Alarms Tries Needed Upgrade

For a more patient alarm system

Thu, Jan 7, 1993

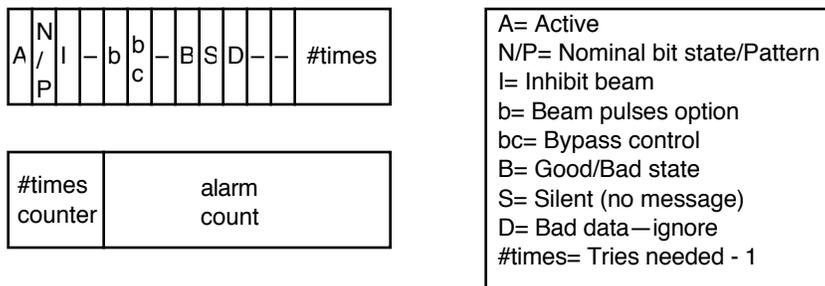
The previous structure of the alarms flags and alarm count words was:

A single bit was used for the two-times option and another for the count to 2.

The new structure for the alarm flags and alarm count words is now:

Here a 4-bit field is used to support *tries_needed* values of 1–16. The 2 and 2c bits are no longer used. The alarm count is now 12 bits to provide room for the counter.

Note that using this scheme for large values of *tries_needed* necessarily delays the response of the alarm system for generating an alarm message and for inhibiting beam for up to 16 cycles—about one second at 15 Hz.
